Case File Number: PLN20124

September 28, 2022

Location:	1431 Franklin Street
Assessor's Parcel Number(s):	008 062100807
Proposal:	Major Conditional Use Permit and Regular Design Review to construct a 27-story (410.5-foot tall) 419,480 square feet office tower with a parking garage above grade.
Applicant:	TC II 1431 Franklin, LLC
Contact Person/ Phone Number:	Kyle Winkler, Tidewater Capital/(510) 290-9901
Owner:	TC II 1431 Franklin, LLC
Case File Number:	PLN20124
Planning Permits Required:	Major Conditional Use Permits for large scale development and tandem parking; Regular Design Review
General Plan:	Central Business District
Zoning:	CBD-P Central Business District Pedestrian Retail Commercial Zone Height Area 7, no limit
Environmental Determination:	Determination Pending, Environmental analysis to be conducted prior to any discretionary action
Historic Status:	Project site is located within an existing listed National Register historic resource, the Downtown Historic District Area of Primary Importance (API).

City Council District:	3
Finality of Decision:	No decision by DRC; receive public testimony and provide comments on design.
For Further Information:	Contact case planner M

TOWER DESIGN
FACADE DETAILS

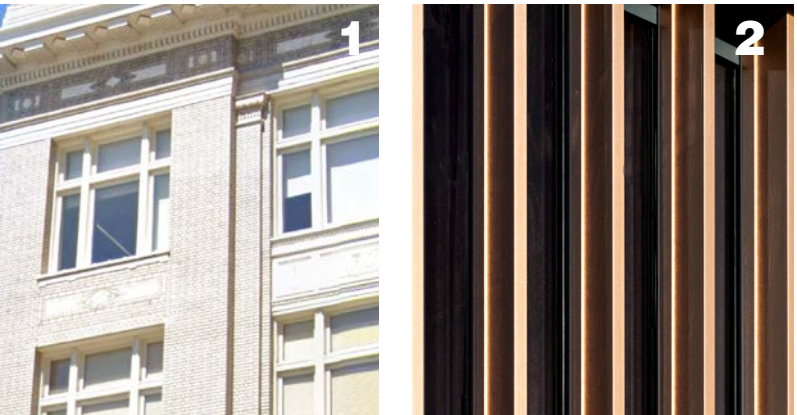
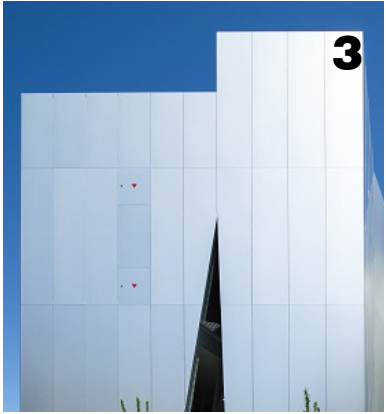
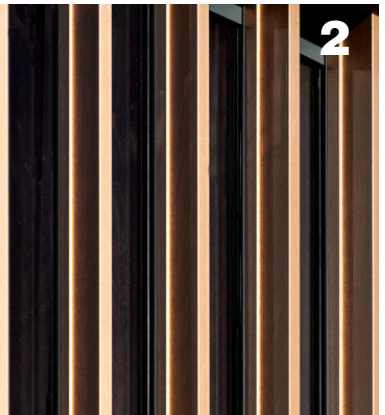
- **Compatibility of New Construction.** The plans lack the dimensions of the recessed windows and the metal fin on the building façade, and gives no details on window operation, window framing and trim. Section 17.136.055 B – Special regulations for historic properties in the Central Business District and the Lake Merritt Station Area District Zones, 2. Findings, subsection A, states:
 - Any proposed new construction is compatible with the existing API in terms of massing, siting, rhythm, composition, patterns of openings, quality of material, and intensity of detailing...
 - *Does the DRC think that the design lacks specificity of quality of materials and intensity of detailing?*

a. Any proposed new construction is compatible with the existing API in terms of massing, siting, rhythm, composition, patterns of openings, quality of material, and intensity of detailing;			N	Staff is concerned that the design lacks specificity of quality of materials and intensity of detailing. The plans lack the dimensions of the recessed windows and the metal fin on the building façade, and gives no details on window operation, window framing and trim.
